# GPIB ASIC Reference Manual

## Errata

The changes described in this document are important information for users of the *NAT7210 Reference Manual*, the *NAT9914 Reference Manual*, and the *TNT4882 Programmer Reference Manual*.

**Figure 1.** New Figure C-7 for Page C-22

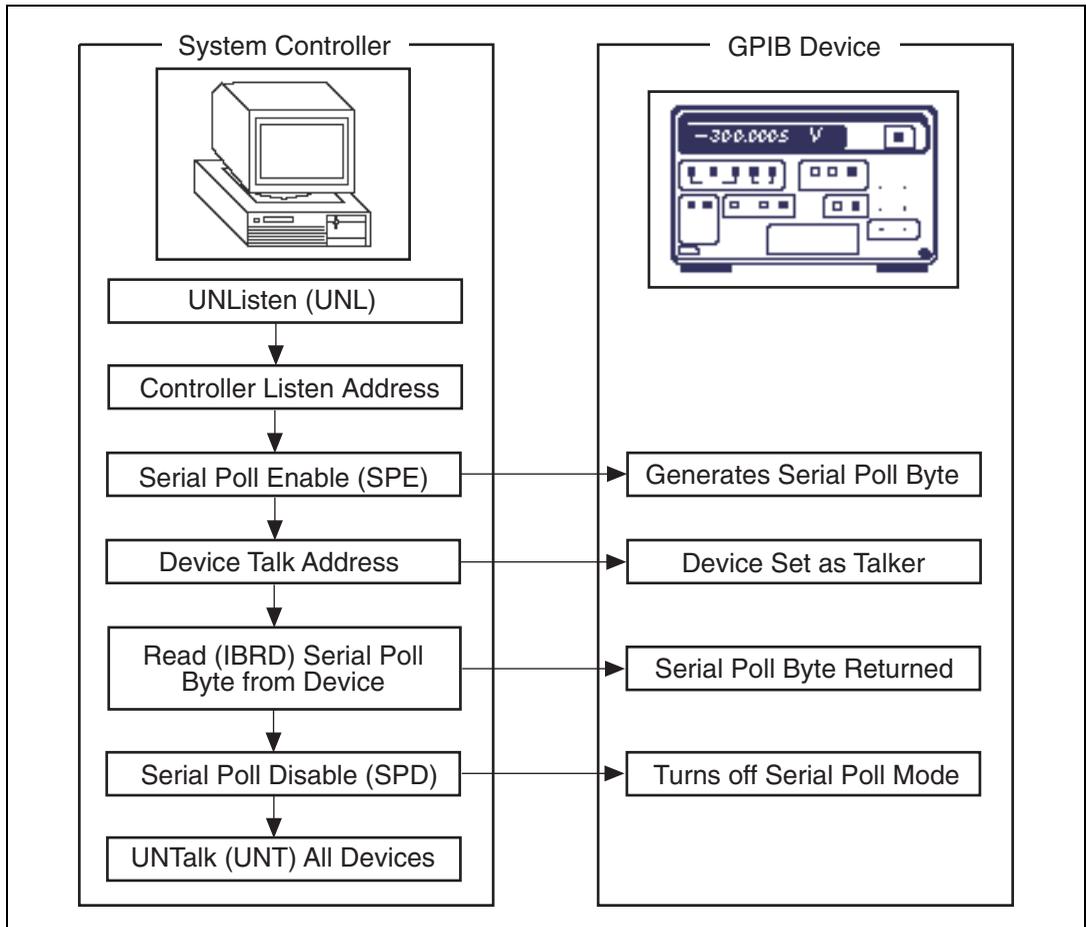
- Page C-22, replace the existing Figure C-7 with the following figure,
